AWC DATABASE CATALOG/ATLAS
CORRECTION FORM

Map: Juneau B-6

Water Body Number: 114-23-10070-2013

SUBJECT: 2016 AWC Habitat Revisions

Figure 1.—Uncataloged tributary to Stream No.114-23-10070.

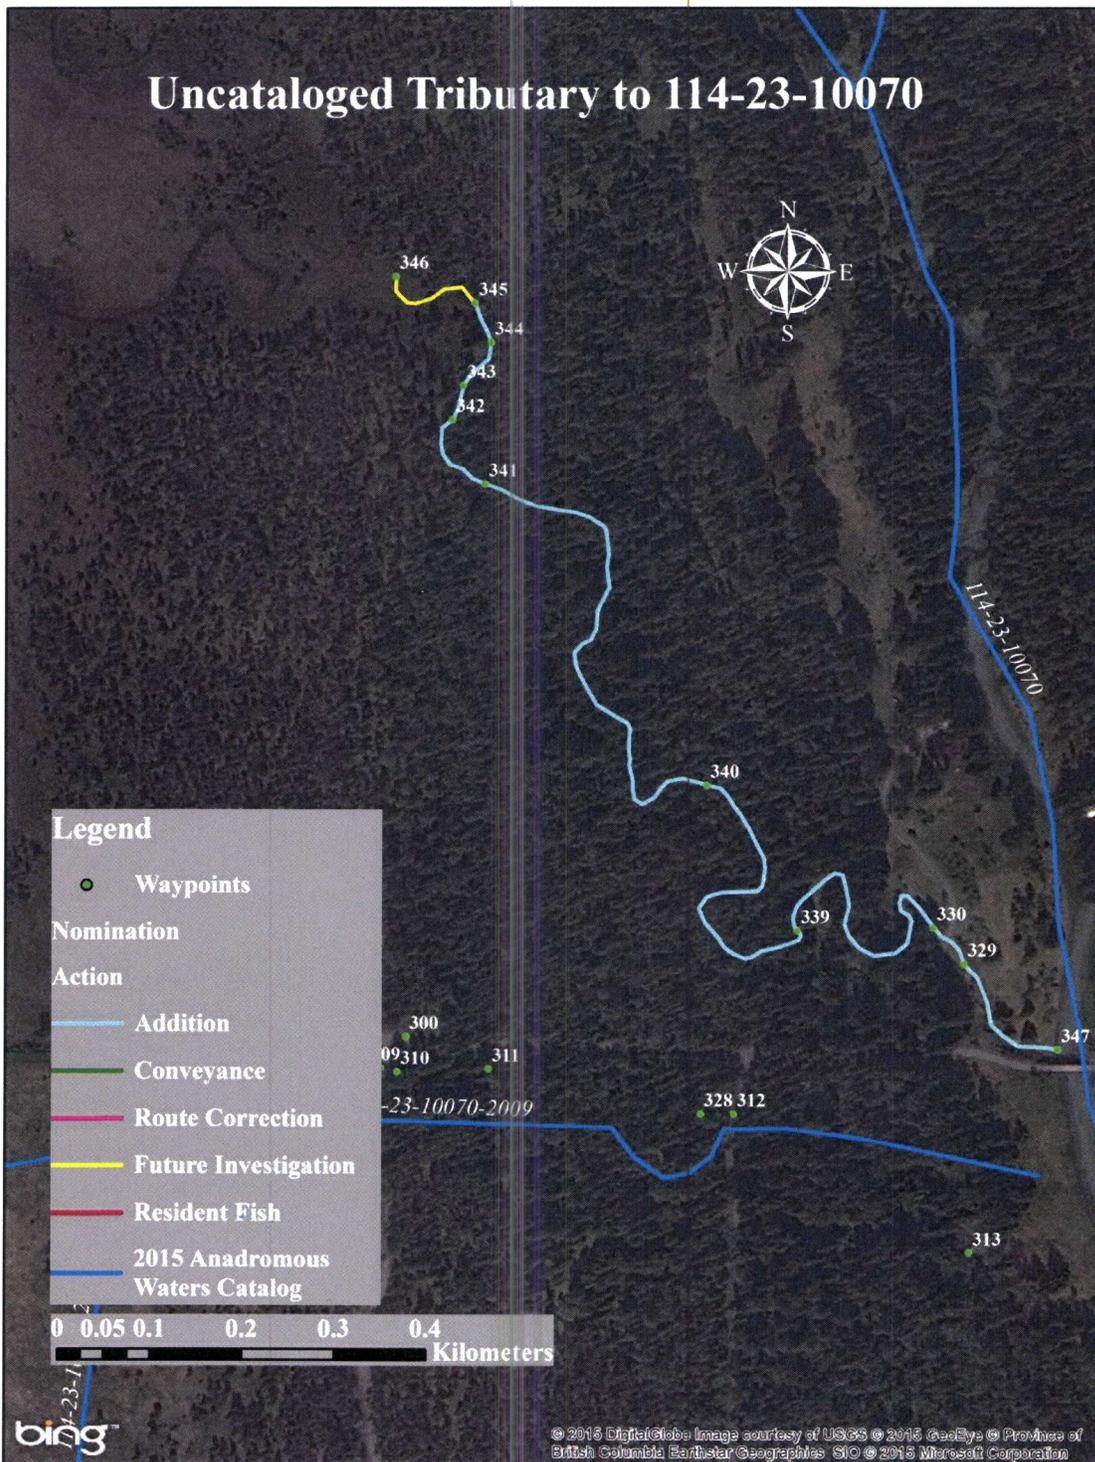
Describe Change(s): Remove name "Good River" from 114-23-10070-2013

Add name "Good River" to 114-23-10700

| Nomination # | Revision |
|--------------|---|
| ✓ 15-638 | <ul style="list-style-type: none">Waterbody # 114-23-10070 should be named *Good River, not tributary 114-23-10070-2013. |

Comments:
Uncataloged tributary to 114-23-10070. Rearing coho salmon visually observed and captured in minnow traps (see nomination PDF).
Coordinates (Lat,Long): Upper(58.4164,-135.7779) Lower(58.4125,-135.7731)
Add new creek w/ coho salmon rearing add barrier @ upper pt
add local name * Good River to 114-23-10070

add new creek 114-23-10070-2013
w/coho salmon rearing, add barrier @ upper extent,
use 2016\noms\zutz\NOM 15-638 Addition Arc\NOM_15-638_Addition.shp for hydro
